Technological Arts, Inc.

Title: **Adapt9S12XDP512M2 Microcontroller Module**		
Size: C	Document Number: FILE: AD9S12XD.DSN	Rev: 1b
Date: Wednesday, June 17, 2015	Sheet 1 of 1

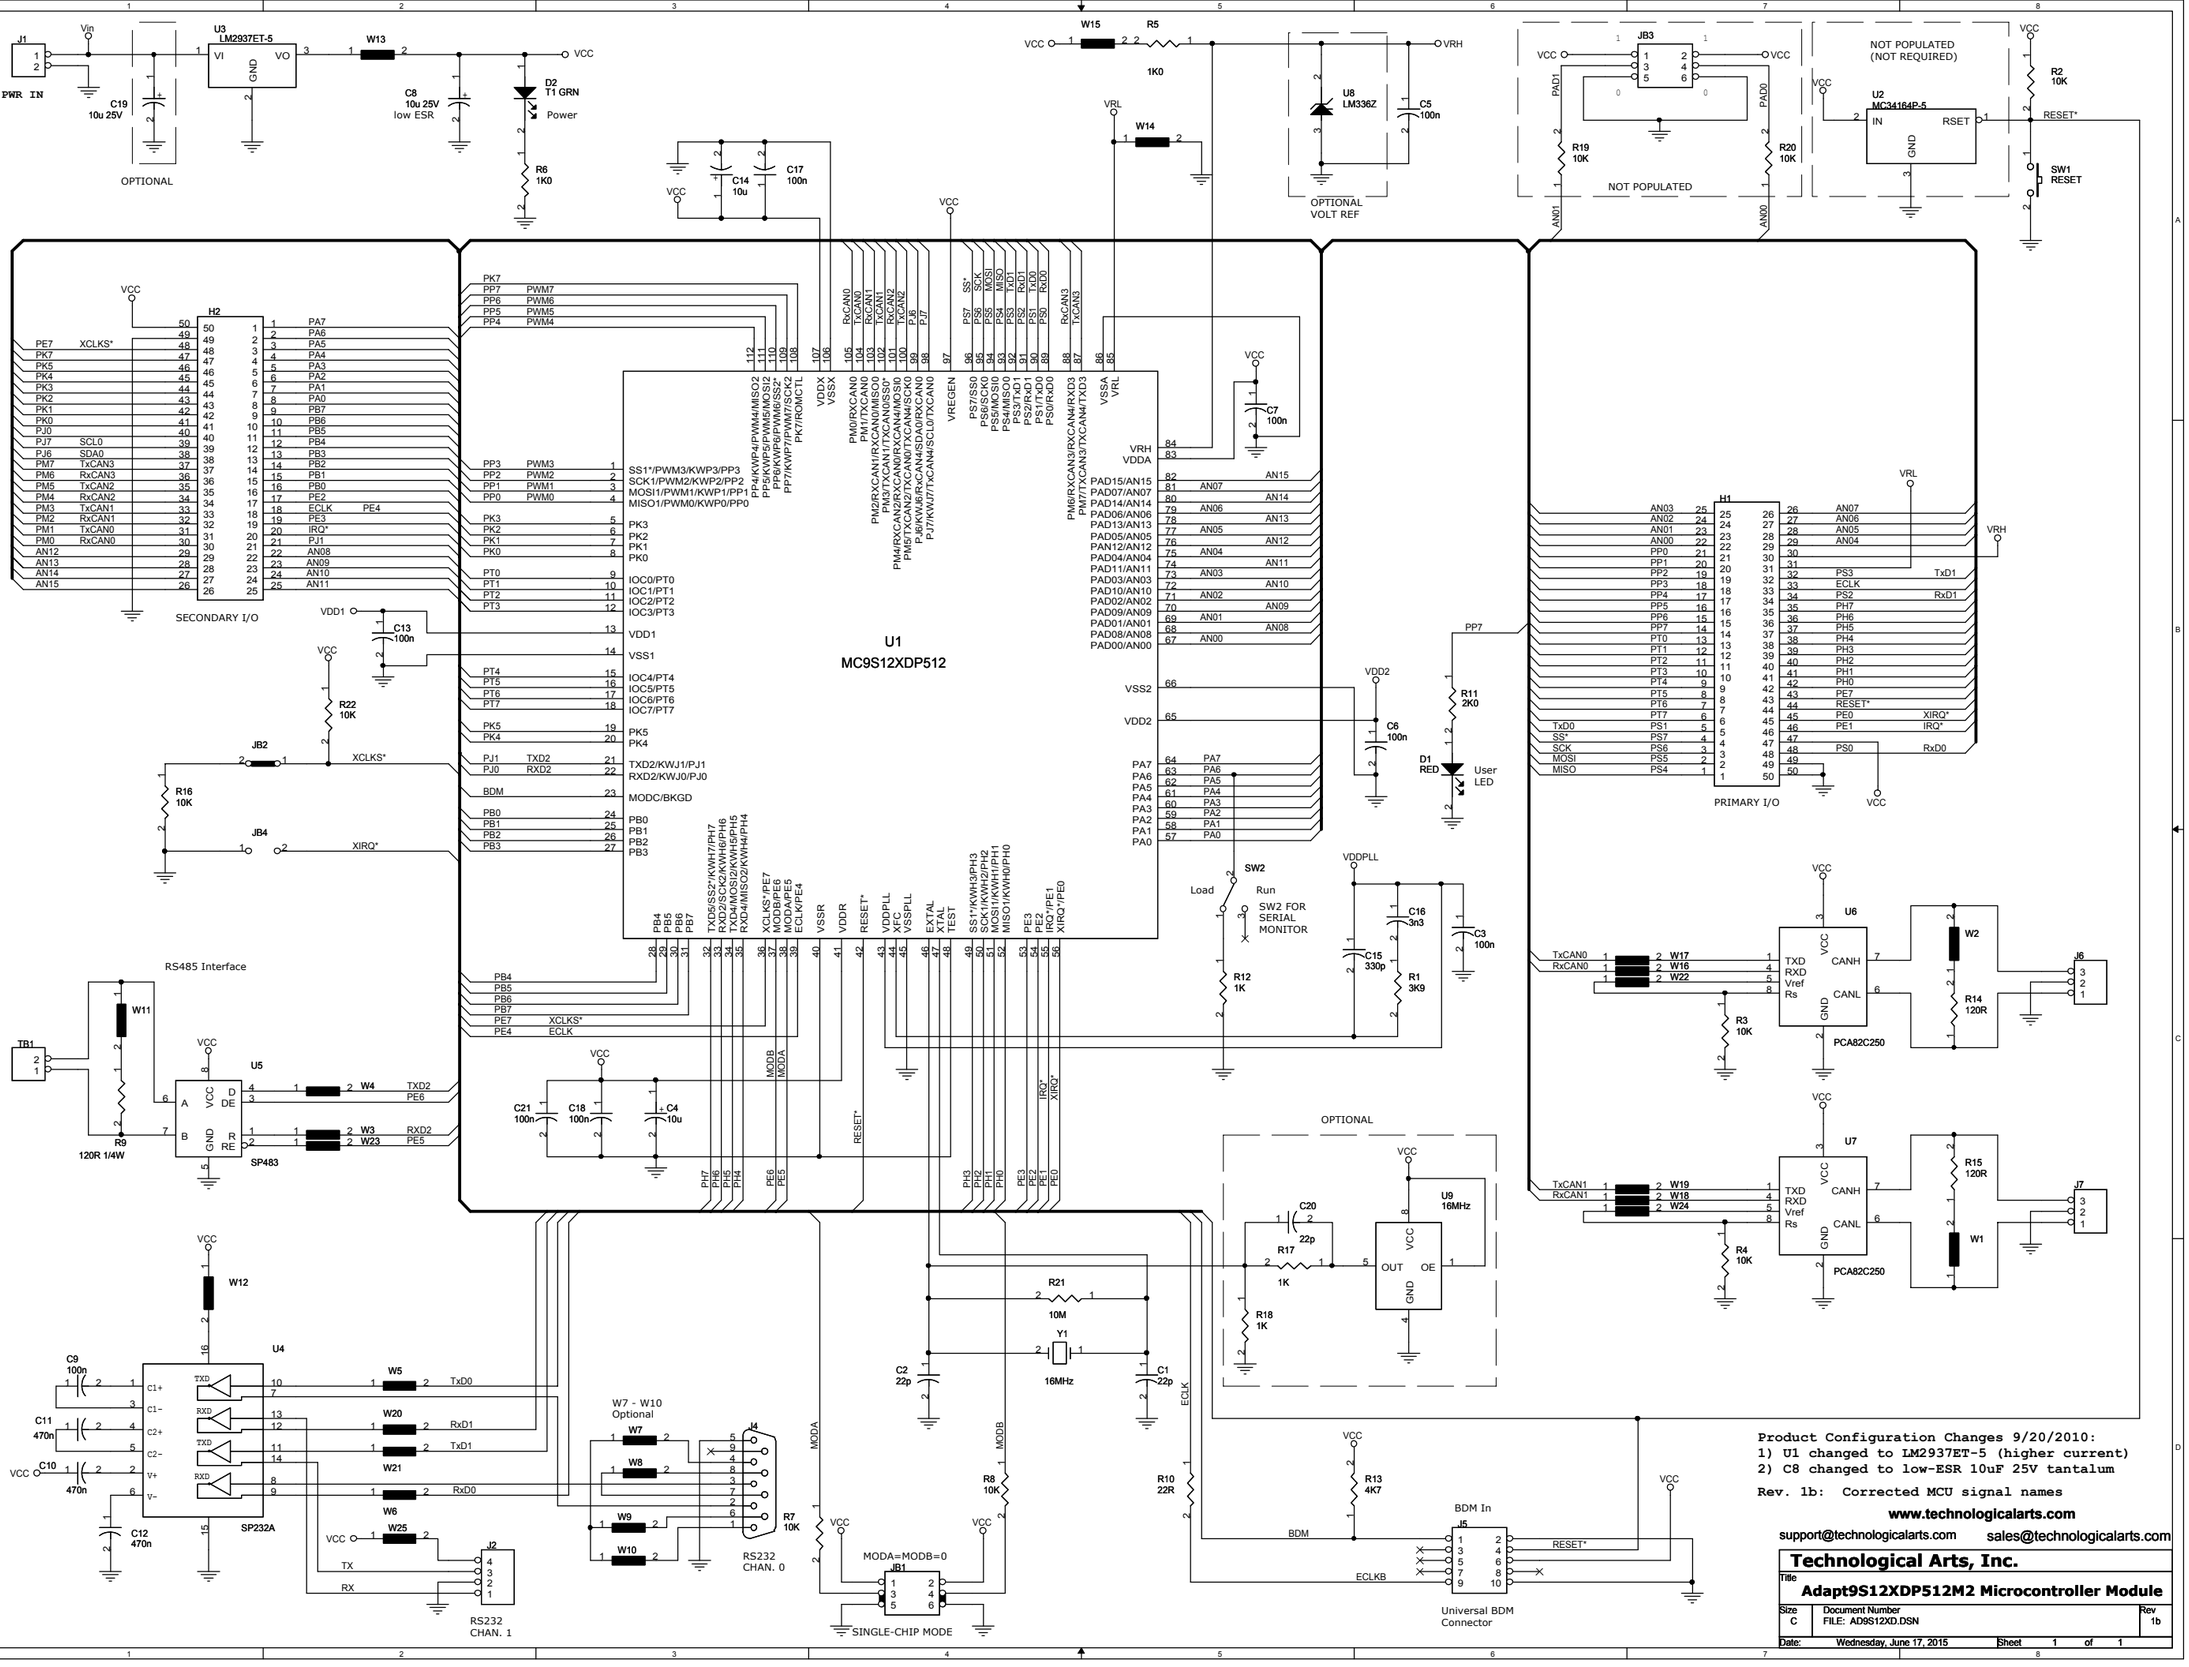
Product Configuration Changes 9/20/2010:
1) U1 changed to LM2937ET-5 (higher current)
2) C8 changed to low-ESR 10uF 25V tantalum

Rev. 1b: Corrected MCU signal names
